Special Meeting Agenda
Tolland Inland Wetlands Commission

1. Call to Order
2. Seating of Alternate(s)
3. Public Participation – Issues of concern not on the Agenda (2 minute limit)
4. Old Business
 - 4.1 **IWC 23-6 – 343 Plains Road** – Proposed improvements to existing Camp Yankee Trails. Regulated activity within the 200’ upland review area is 1.10 acres/48,024sqft and regulated activity within the 50 feet of a wetland is 0.09 acres/48,024sqft. Zone: Residential Design District (RDD) Applicant: Girl Scouts of Connecticut.
5. Adjournment

CAMP YANKEE TRAILS SITE IMPROVEMENTS

- Item 1 Eight (8) revised plan sheets entitled "Camp Yankee Trails Site Improvements, 343 Plains Road, Tolland, Connecticut", sheets GR-2, GR-4, UT-2, SE-1, SE-2, SE-3, SD-4, and SD-5, prepared for Girl Scouts of America, prepared by SLR, dated November 21, 2023, revised December 20, 2023
- Item 2 Drainage Report, Camp Yankee Trails Site Improvements, 343 Plains Road, Tolland, Connecticut, prepared by SLR, dated November 20, 2023, revised December 20, 2023
- Item 3 Tolland Inland Wetlands & Watercourses Commission Comment Response Letter, addressed to Michael D'Amato, prepared by SLR, dated December 20, 202

STORMWATER BASIN 110 INFILTRATION STONE
NOT TO SCALE

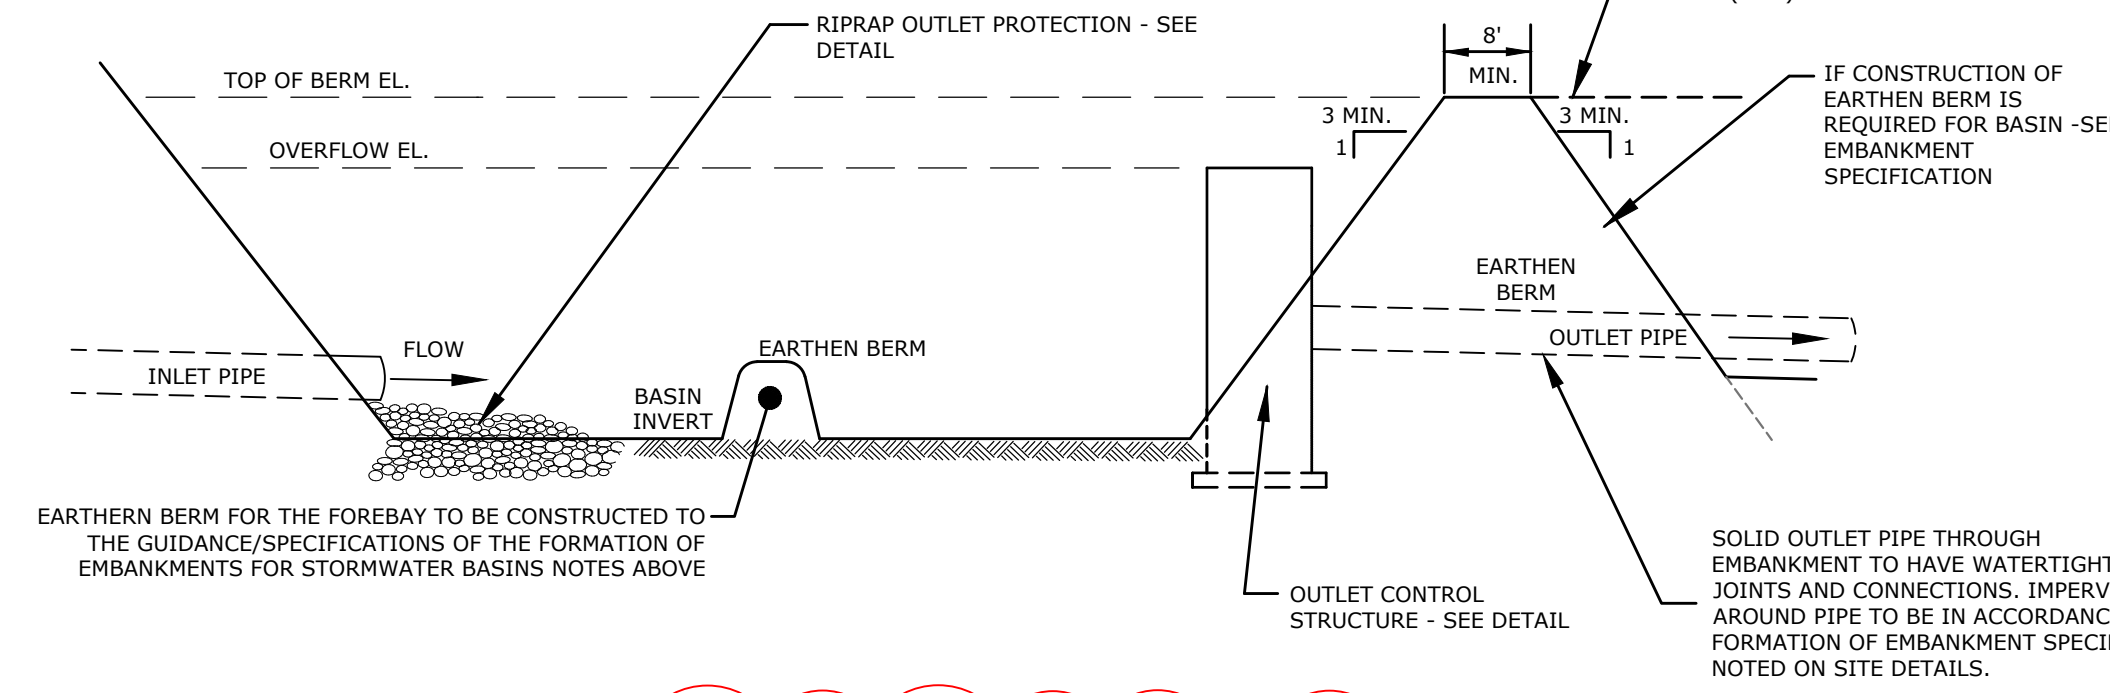
- ***Emergency weir elevation: plan 449.2, calculations 449.0***
- ***Overflow grate elevation: Plan Sheet GR-2 449.4, correct elevation 448.0***
- ***Stormwater Basin 110 Infiltration Stone Detail: Sheet SD-5 Bottom Elev 448.0, correct elevation 445.0***

- R6. A stone wick has been added to Stormwater Basin 110, which will be hydraulically connected to an infiltration stone layer beneath the topsoil layer of the basin. This stone layer will be the same area as the bottom of the basin and will interface with the native soil, supporting the use of an infiltration rate of 27.4 inches per hour. A detail has been provided on Sheet SD-5. Onsite sandy loam soils will be used for the topsoil growing medium.**

OUTLET PROTECTION ID	TYPE	SP (FT)	RP (FT)	C (FT)	B (FT)	F (FT)	D (IN)
FES 5	MODIFIED TYPE 1	1.0	1.0	6.0	5.0	0.5	12

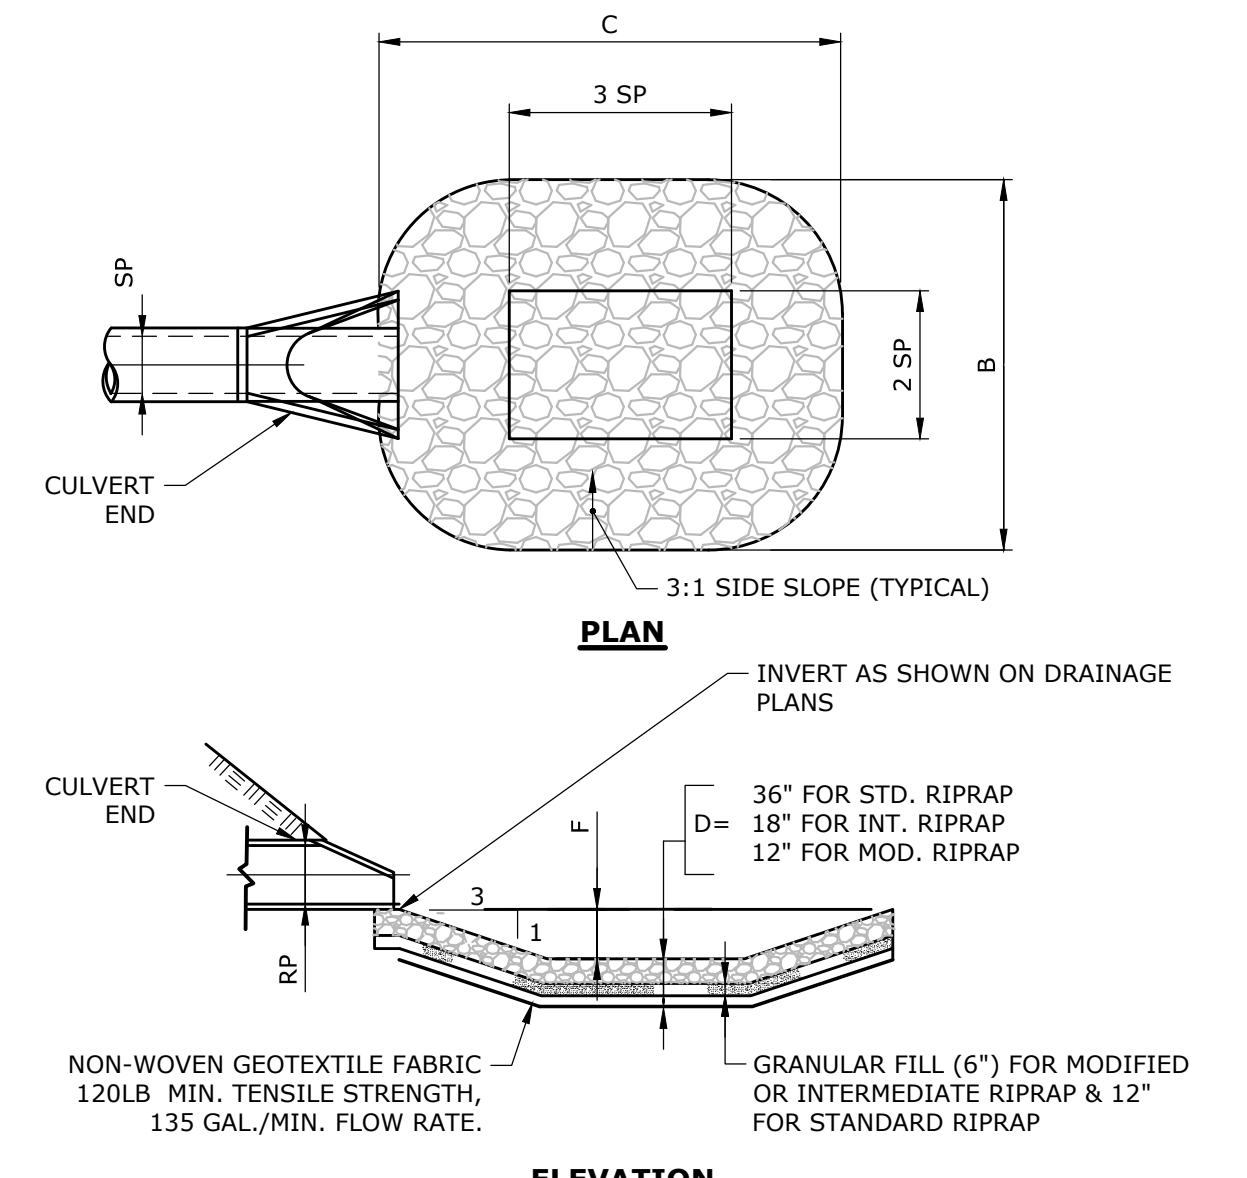
16. The Preformed Scour Hole Detail on Sheet SD-5 must be updated to correctly identify FES 5.

- R15. A stormwater operation and maintenance plan has been included as part of the revised Drainage Report.**
- C16. The Preformed Scour Hole Detail on Sheet SD-5 must be updated to correctly identify FES 5.

16. The Performed Scour Hole Detail on Sheet SD-5 must be updated to correctly identify FES 5.
Provided. This comment is addressed.
